Farnborough Noise Group evaluation of the PIR response submitted to the CAA

31st May 2023

Part 1 - Summary review of (PIR) report

Prior to the ACP, flightpaths and swathes were reported in the 2014 ACP document Part B

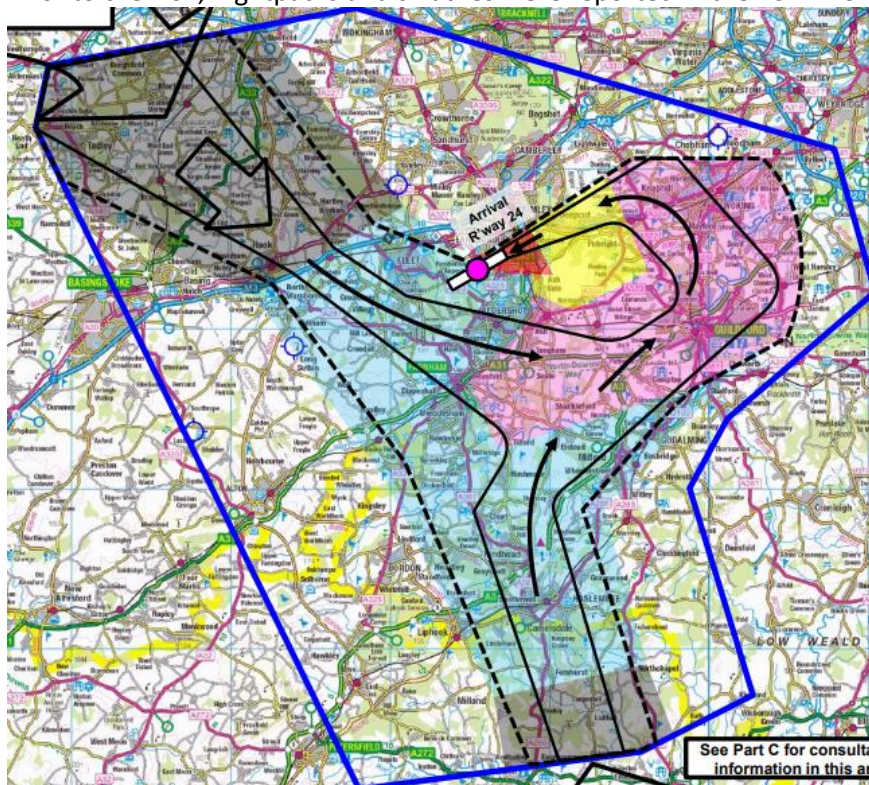
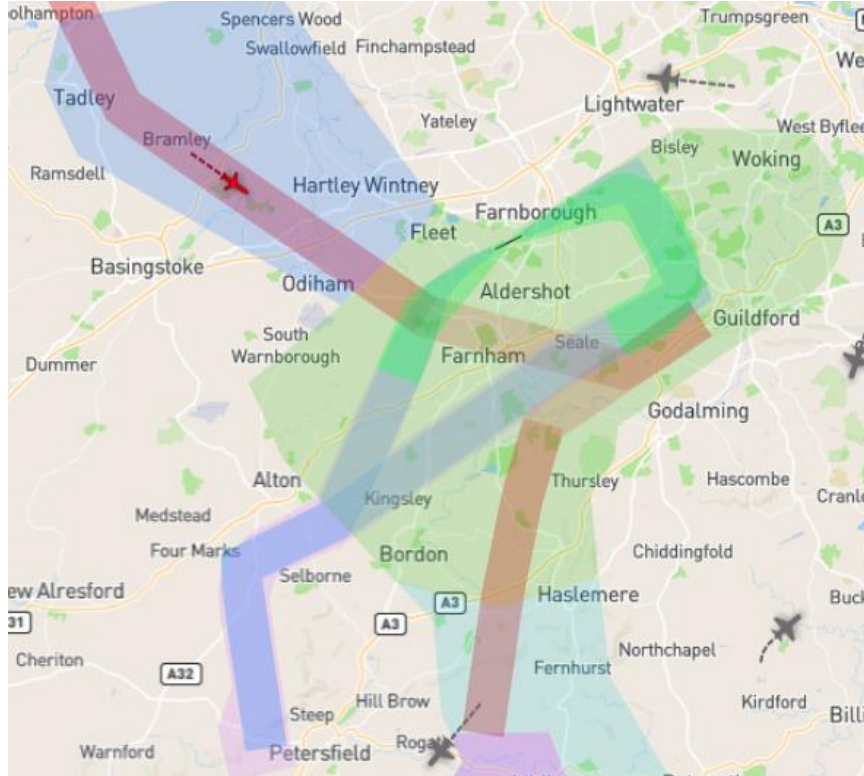
CAP 1678 justified the ACP in part due to the projected reduction in the number of people overflown. It claimed that 200,000 fewer people would be overflown below 4,000ft. If anything, the swathes have increased and there is no evidence that fewer people are overflown. What has happened is that many flights are now concentrated in a very narrow band so, while the same number of people experience overflying, a sub-set of those people now experience a very large increase in overflying. The other fundamental failing in the PIR data as presented is that it only considers Farnborough aircraft. The ACP has had a much more extensive impact on GA in some areas (Such as the area between Frensham and Shackleford) that have seen the typical number of aircraft overflying increase from 5 – 10 a day pre-ACP to 80 – 100 a day post-ACP. The purpose of the PIR is to evaluate the full impact of the ACP, not just the impact on Farnborough aircraft.

These are the flightpaths and swathes following the ACP – almost no difference

Furthermore, since many aircraft do not follow the defined flightpaths or swathes (as seen in charts in Section 8), the perceived benefit of the number of people overflown cannot be claimed. The claims of reduced number of people overflown are therefore invalid and the CAA itself advises that caution should be used in interpreting the data. The large grey areas stating “typically less than one overflight per day” can still be 5-10 flights in a day but averaged over a month become less than 1. This would not be an experience of “reduced overflying” by people on the ground and indeed the report concluded that no members of the public have reported reduced overflying (Annex D Feedback 6.1.8).

Example of aircraft not following correct departure flightpath

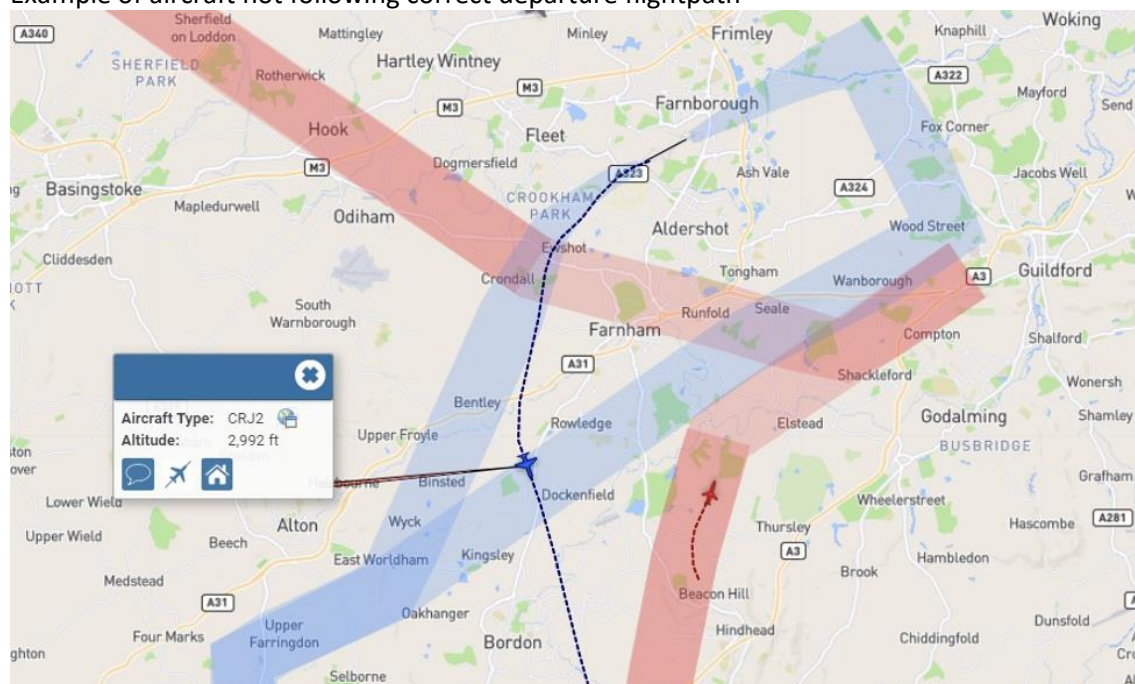
While the majority of flights follow the flight tracks, not all do. Most but not all departures follow the correct departure flightpath (SID).

Example of two aircraft not following the correct arrival flightpath (STAR) or swathe

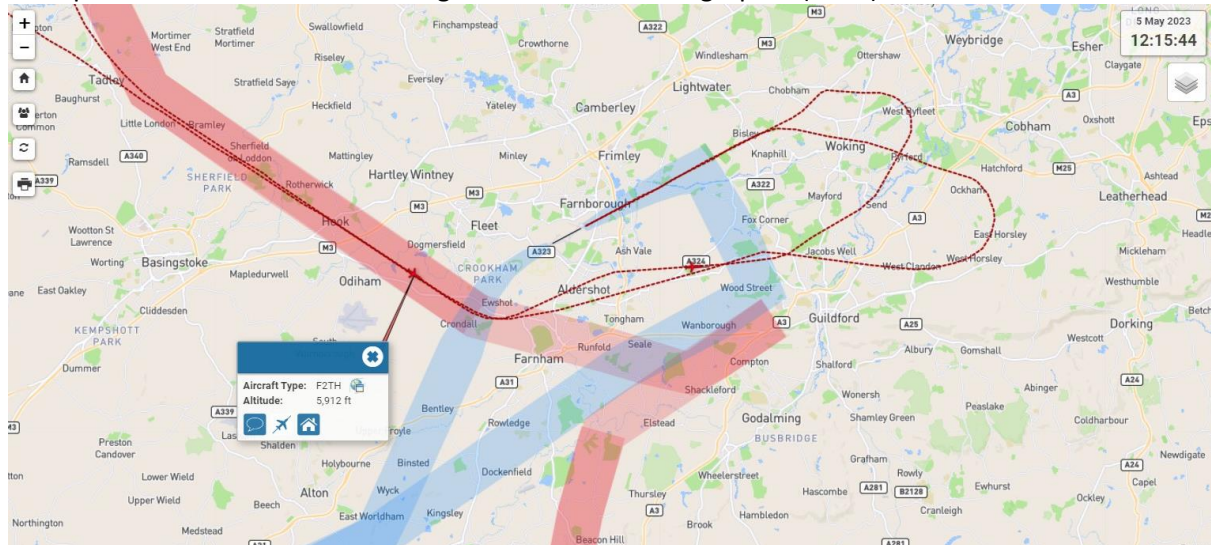
Between 10% and 30% of flights do not follow the correct arrivals flightpath (STAR) and effectively there is a “block” of airspace between Farnborough to the north, Haslemere to the south, Godalming to the east and Alton to the west where aircraft fly anywhere. There are hundreds of examples of aircraft not following these flightpaths. Either there are flightpaths or there aren’t. It can’t be both when it suits NATS or pilots. Now that FAL has included the “swathes” in Webtrak (see below), the area that aircraft fly is considerably larger than the flightpaths in the 2014 consultation

Example of aircraft not achieving 4,000ft by A31 following Runway 06 departure

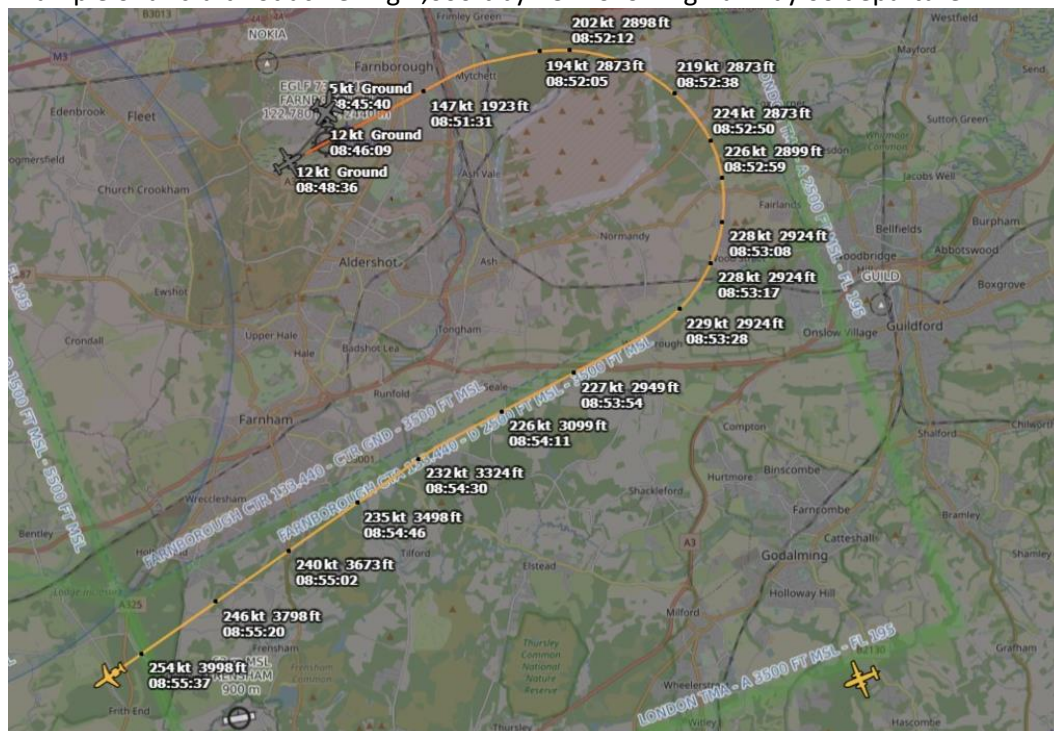
Figure 2 in section 2.3 suggests that most aircraft are achieving an altitude of 4,000ft by the time they cross the A31 following a runway 06 departure. This is generally not correct and it undermines the validity of data presented. The majority of runway 06 departures do not reach an altitude of 4,000ft until south of Farnham. Statements 2.3.4, 2.3.6 are patently incorrect. Evidence to support this can be provided.

Example of 360 degree “loop” over Farnham

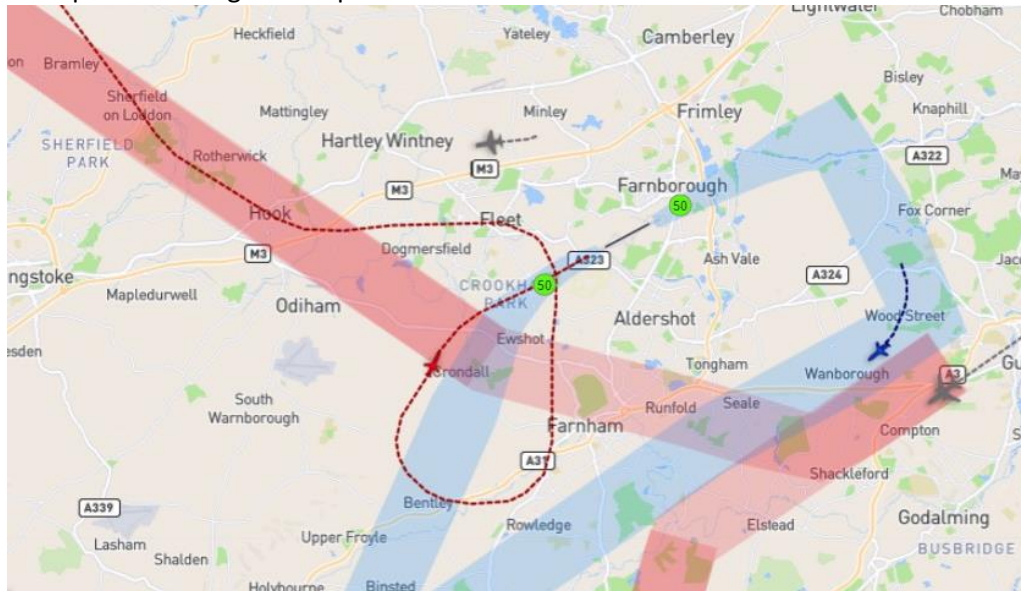
Figure 16 and Section 3.5.4 are a completely untrue representation of flightpaths. The reality is that post ACP, every arrival from the north to runway 06 now flies twice over the same people west/south west of Farnborough. This is not shown in any of the charts in this annex.

Example of southerly arrival landing on runway 06

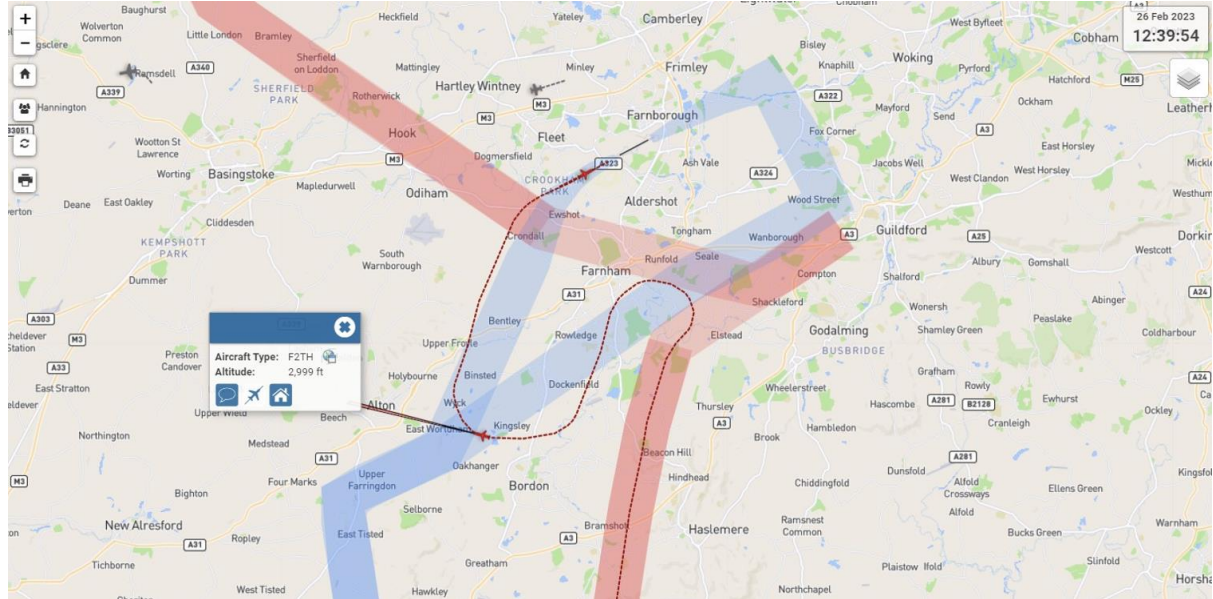
Equally, southerly arrivals to runway 06 frequently do not fly the route described in 3.5.4. They fly a route as shown in the figure below which results in multiple noise disruption.

GU10 postcode area with Churt at the south

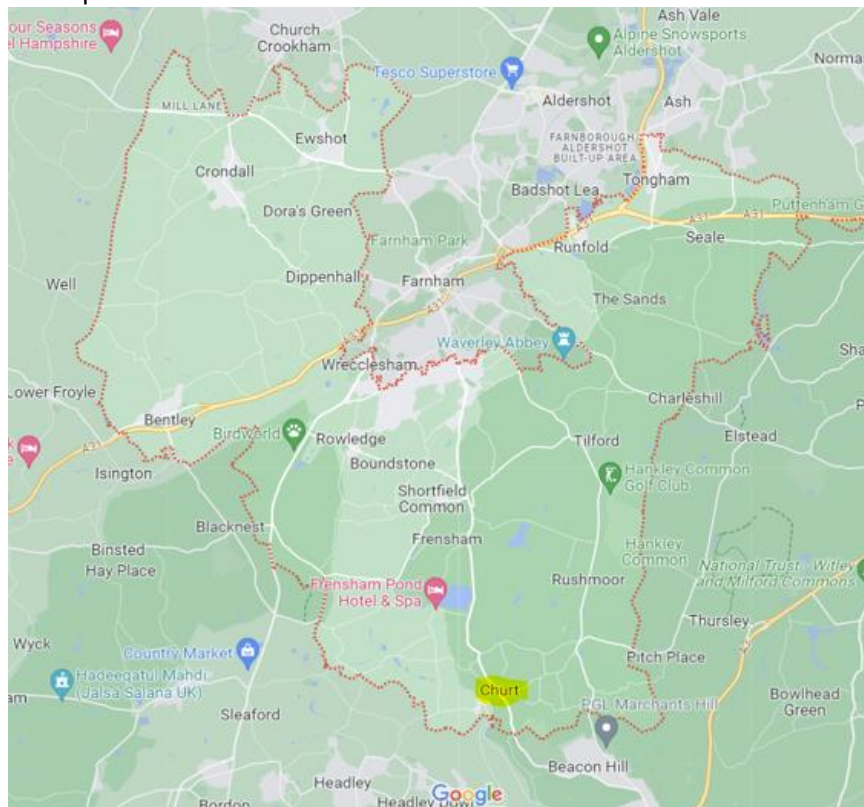
Section 3.9 purports to be an analysis of the GU10 area and references Churt. However, Churt is at the very south of GU10 and the commentary in this section is not correct for most of GU10. The areas of Bentley, Rowledge, Tilford and Charles Hill are much more impacted than Churt because they experience Farnborough aircraft at lower altitude, more flightpaths over them and experience much more General Aviation rat-running south of CTR 1. These villages also experience the northerly arrivals for runways 06 and 24. It is therefore biased to select one particular village in GU10 furthest away from the airport. In order to assess the true impact in GU10, detailed analysis of Frensham or Tilford would be a much more appropriate location.

Example of circling to provide separation between arriving aircraft

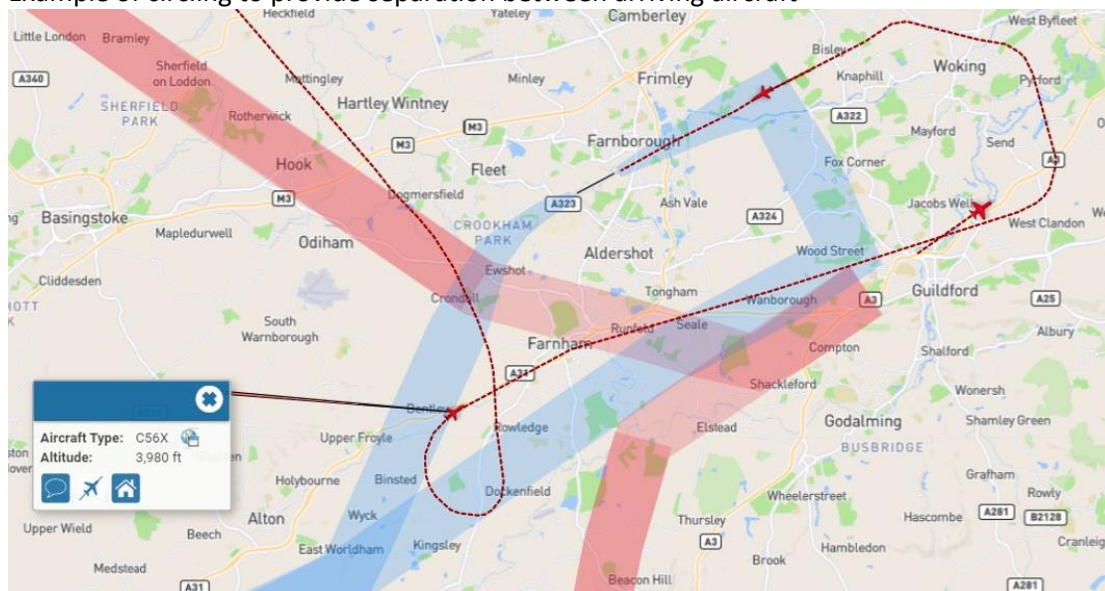
What is needed is an assessment of how many aircraft fly the flightpaths that were set in CAP 1678, how many do not, and the reasons why. Our analysis of daily flight tracks is that most departures are compliant with SIDs but between 10% and 30% of flights do not follow STARs. The situation quickly deteriorates when there are more than 10 arrivals per hour and this results in a significant amount of circling, non-STAR flightpaths and even go-arounds. This is not even recognised in this section and it must be because it results in more noise disturbance, pollution, emissions and risk. Avoiding these situations was one of the main reasons for implementing controlled airspace.
